E3647A-04C**S E R V I C E N O T E**Supersedes:
E3647A-04B**E3647A DC Power Supply****Serial Numbers: MY51240108 to MY53200004****Metal Strap Kit for tightening loose bumper and for fitting rear lock link in side-by-side rack mounting****Parts Required:**

Figure 1: Top view 3mm gap observed between two different chassis designs

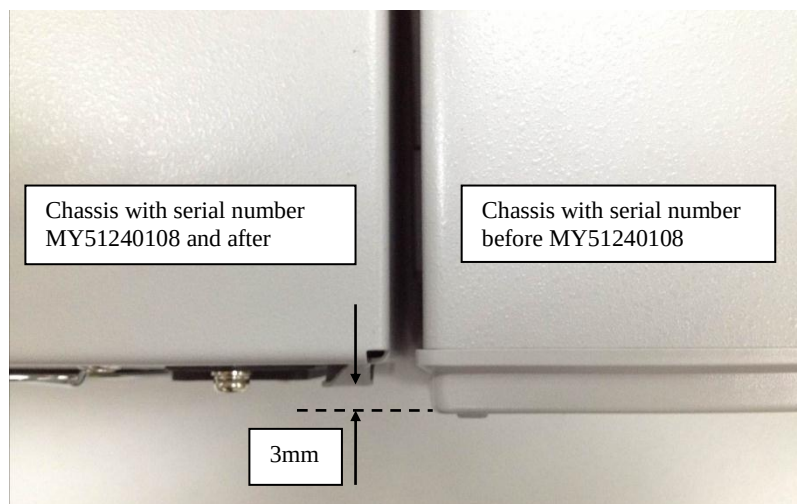
The chassis depth difference between the two designs is 3mm as shown in Table 1 and Figure 1 below.

Serial number range	Chassis depth
MY51240108 and after	345.2 mm
Before MY51240108	348.2 mm

Figure 2: Top view 3mm gap observed on rear lock link for side-by-side rack mounting

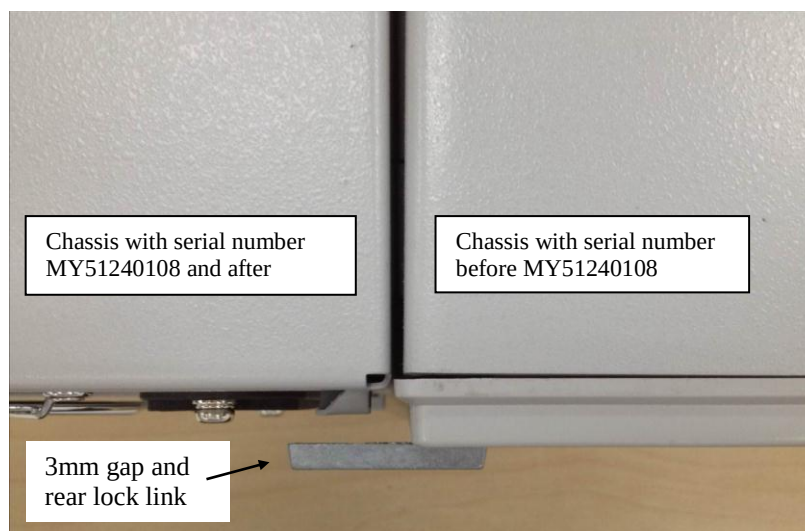
The 3 mm gap between the two different chassis may cause difficulties in securing them together using a rear lock link kit (part number 0050-2167) for side-by-side rack mounting as shown in Figure 2 below.

Use metal strap (part number E3631-07901), and stack the provided two metal straps together to form 3mm thickness and secure it with the provided screws on the rear lock link as shown in Figure 4 below.
